Final Drainage Report  
for  
**Rolling Hills Ranch Filing 2**  
at  
**Meridian Ranch**

EL PASO COUNTY, COLORADO

November 2020

PCD Project No. SF-20-020

## **Appendix E – Regional Water Quality Analysis**

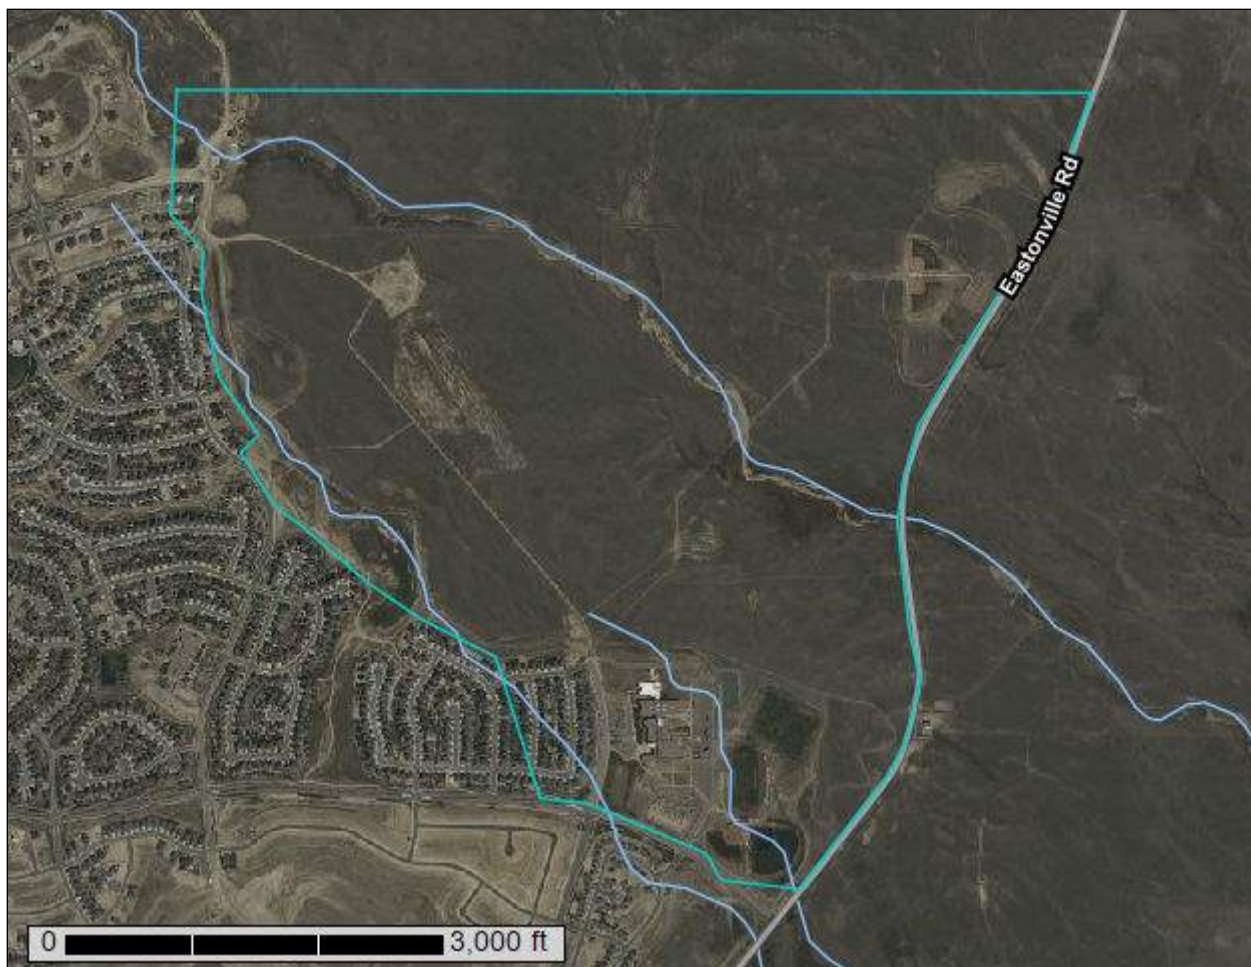
This analysis appears to be missing. Please include. Please be sure to address the previous minor comment provided.

Revised/added

FIGURE 4

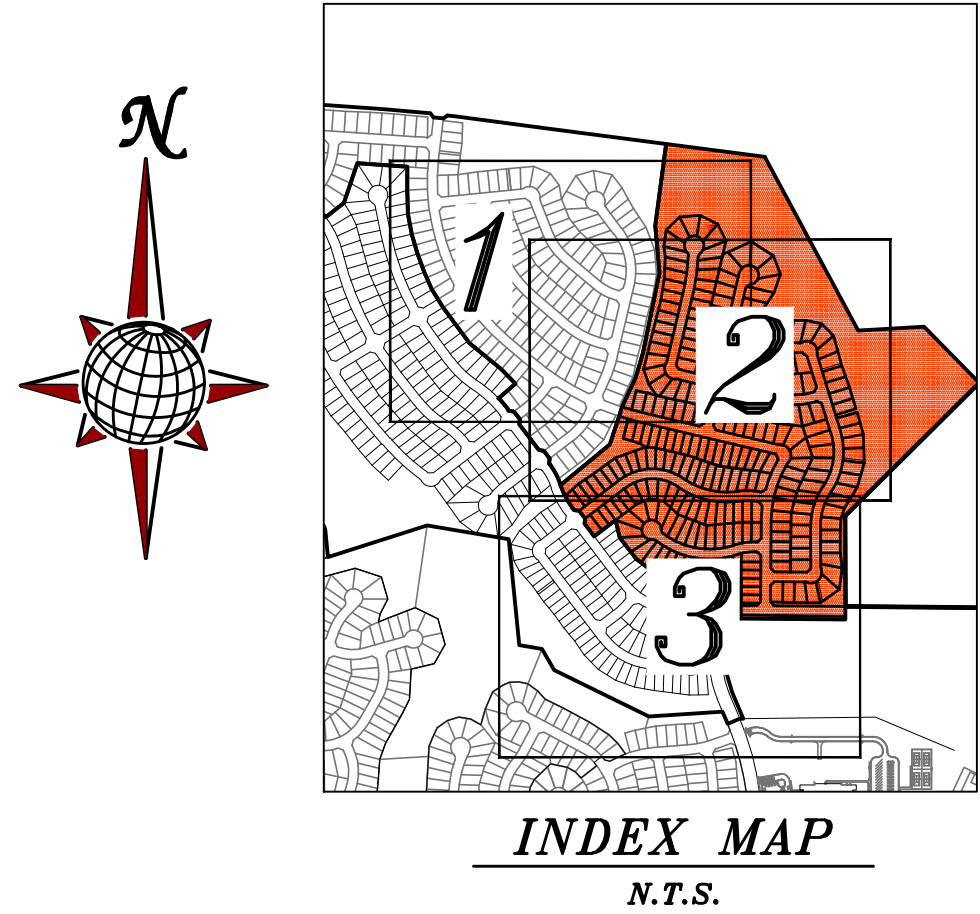
Review 1 comment:  
The basin boundary does not match what is shown on the regional water quality calculation in appendix E. Revise accordingly.  
Review 2: The regional water quality calculation was not provided and therefore i cannot verify whether this comment was addressed.

Review 1 comment:  
Please address water quality for the back of these yards, these were not included in the regional water quality calculation in appendix E.  
Review 2: I Cannot verify if this was addressed as the regional water quality calculations were not provided. Please provide the missing calculations

FIGURE 4

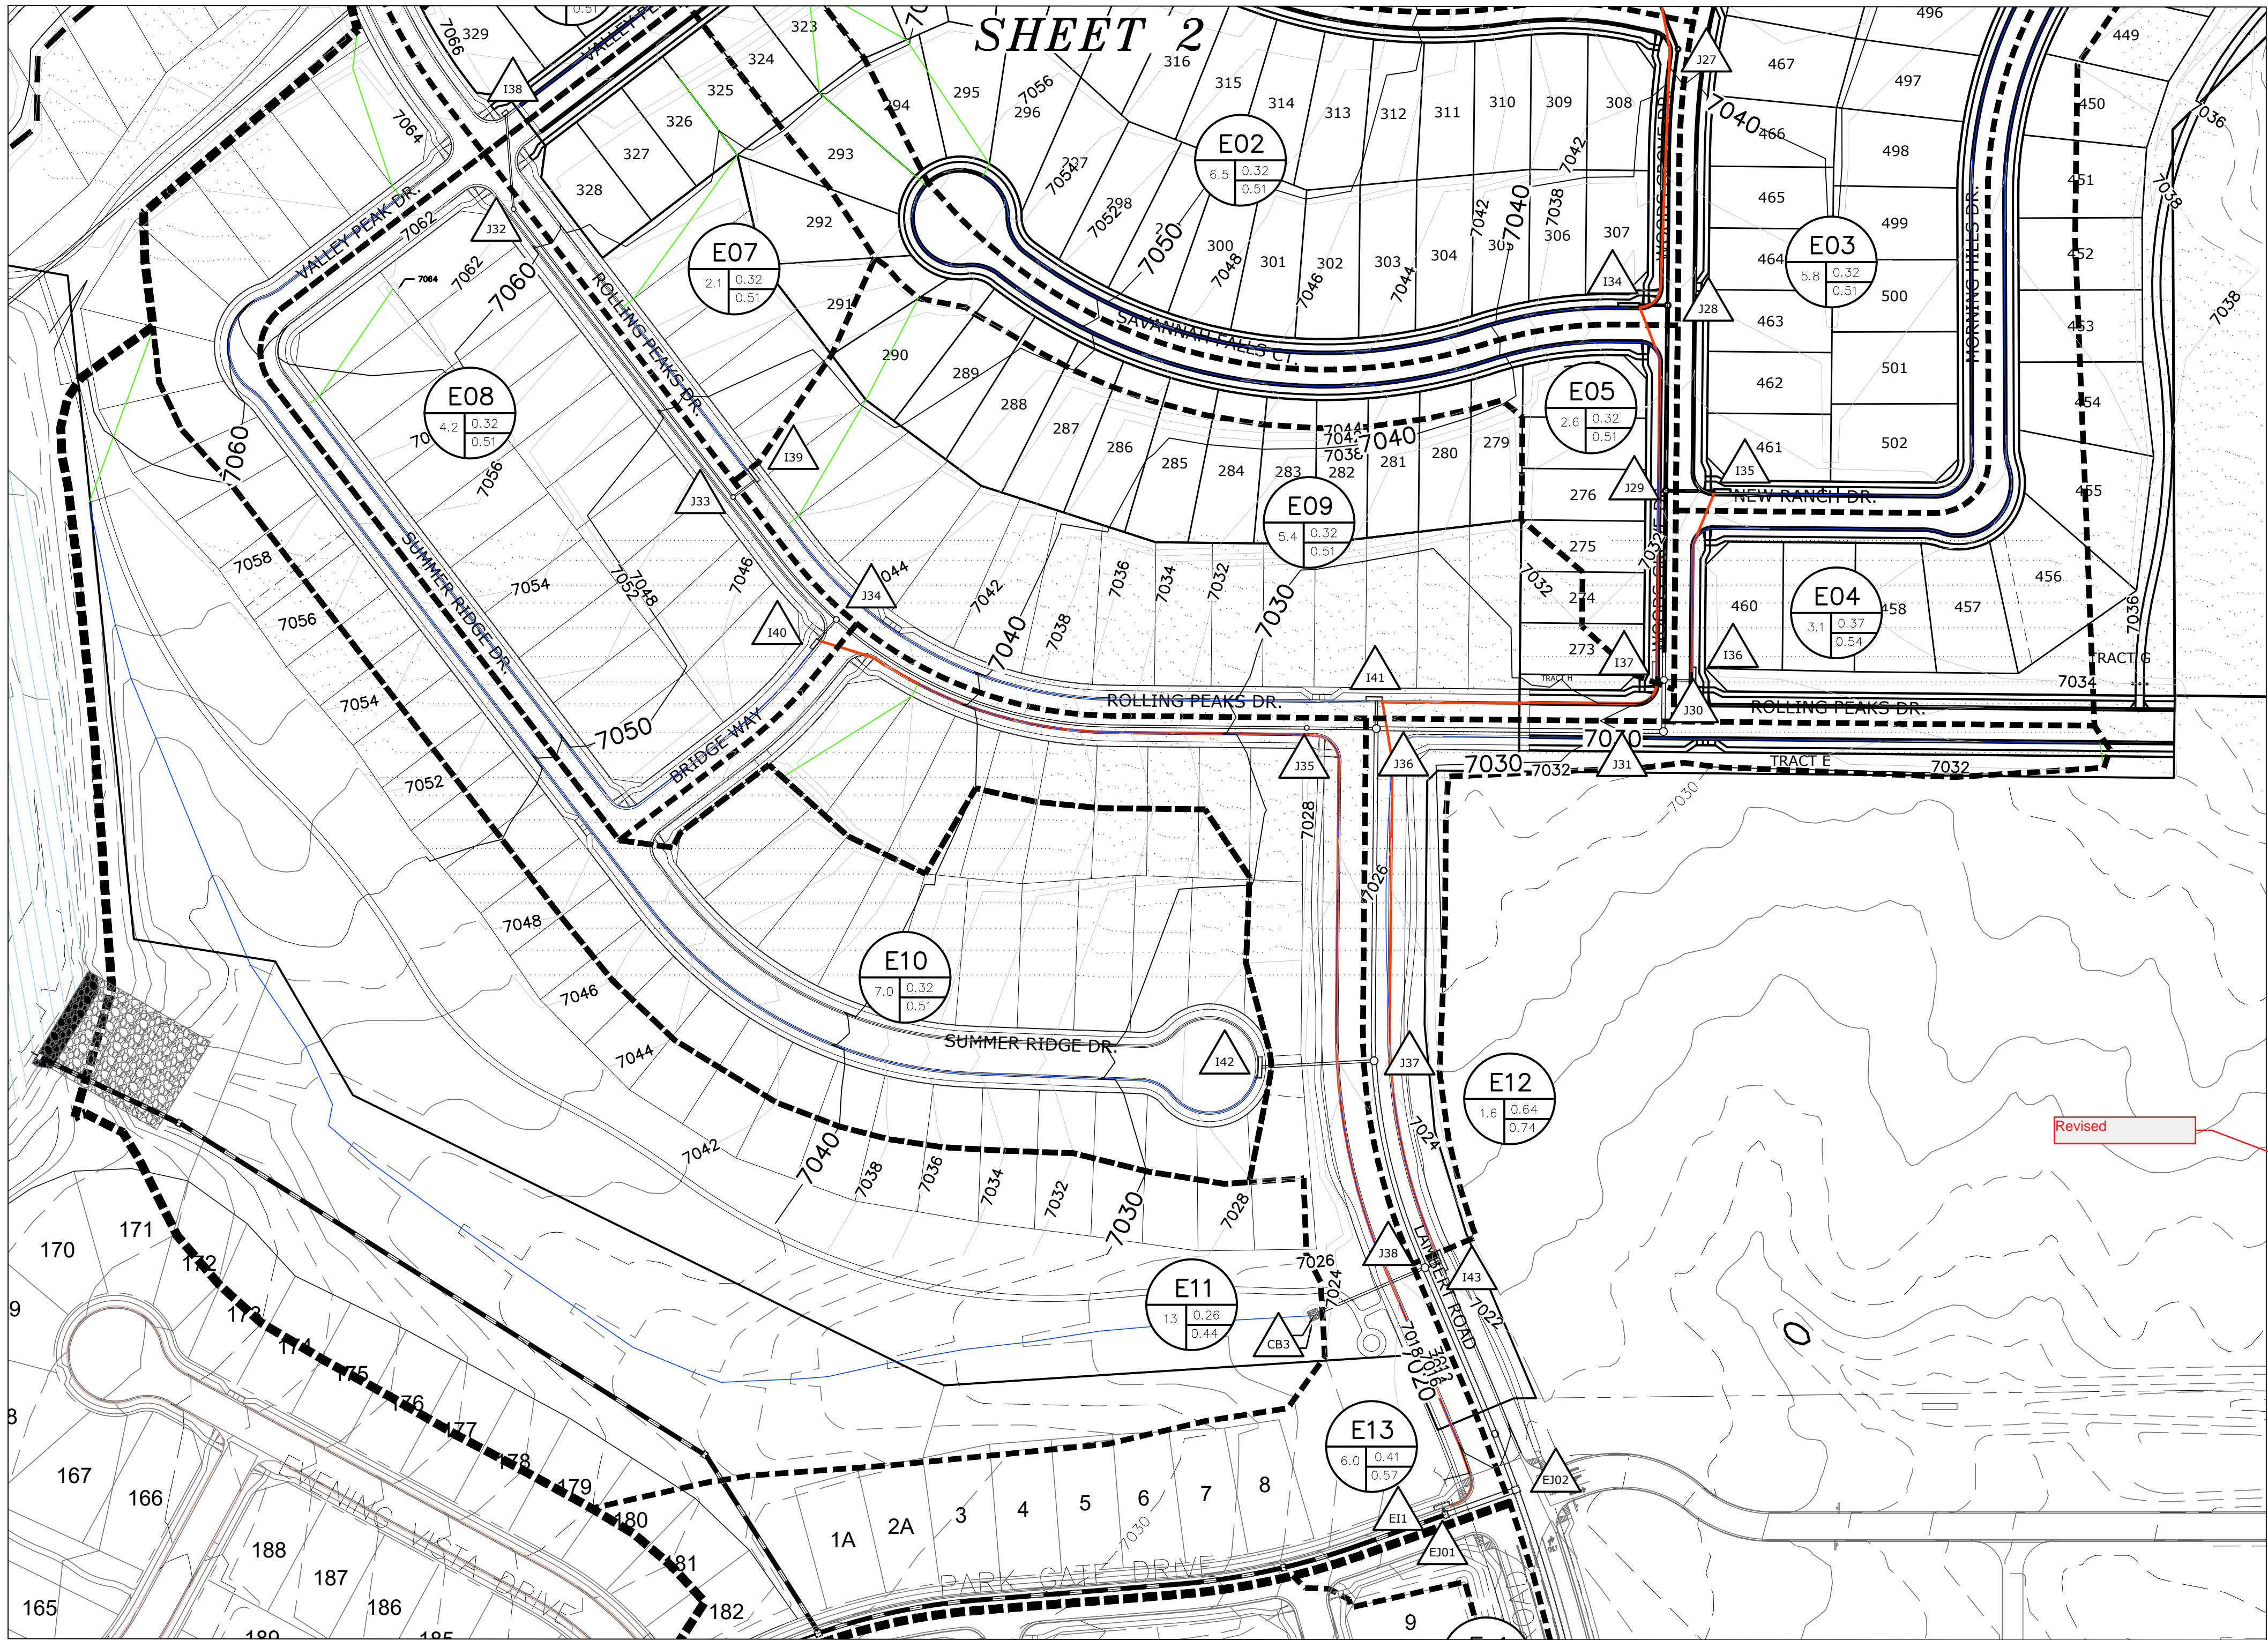
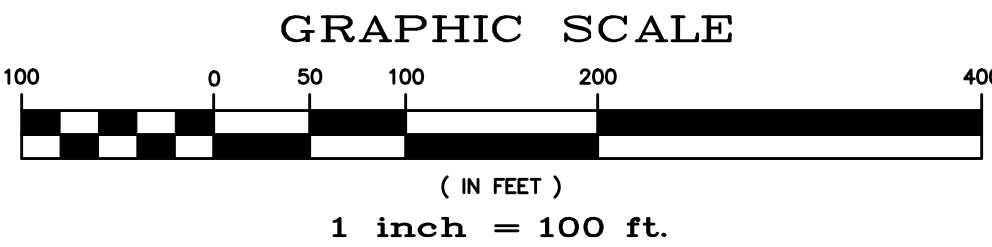
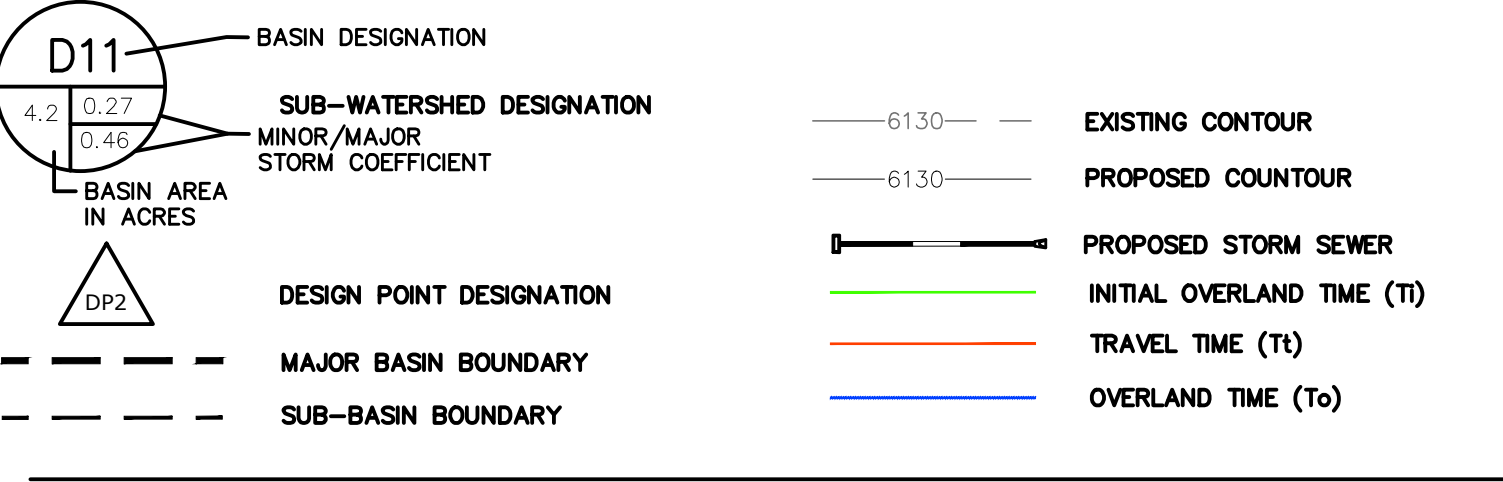
These do not match the hydraulic calculations nor the CD's
